FURTHER REPORT

JRPP PLANNING REPORT

JRPP NO:	2012SYW029
DA NO:	854/2012/JP
PROPOSED DEVELOPMENT:	RESIDENTIAL DEVELOPMENT COMPRISING 126 APARTMENTS AND 34 INTEGRATED HOUSING DWELLINGS.
SUBJECT SITE:	PROPOSED LOT 12 IN APPROVED SUBDIVISION OF LOTS A & B DP 379959 (DA NO. 1639/2011/ZA) – No.'s 75-95 PRESIDENT ROAD, KELLYVILLE
APPLICANT:	NAMUL PTY LTD
LODGEMENT DATE:	13 FEBRUARY 2012
REPORT BY:	SENIOR TOWN PLANNER SOPHIA CHIN
RECOMMENDATION:	APPROVAL

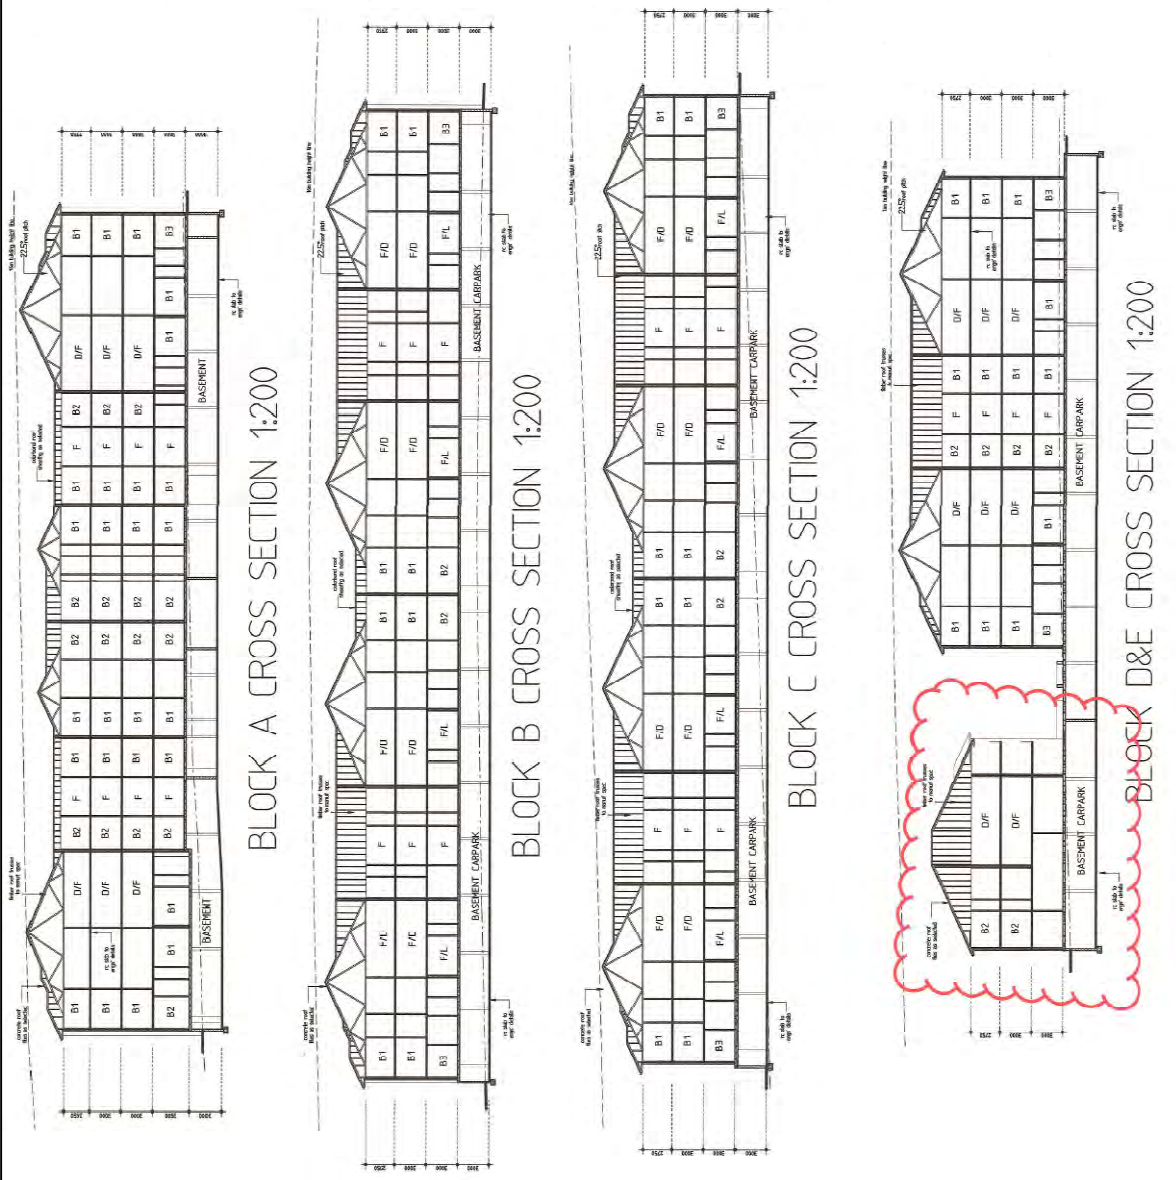
Amended plans were received from the applicant deleting the third storey of Apartment Block D.

The amended development reduces Apartment Block D to two storeys in height and now provides 126 apartments across the site compared to the previous proposal with 133 apartments. The amended residential flat building components of the development include the following:

A comparative analysis of the previous and now amended eastern and western elevations of Apartment Block D is provided below:

The amended plans provide improved integration with the surrounding low density character of the area whilst enabling the bulk of the development to be accommodated to the centre of the site.
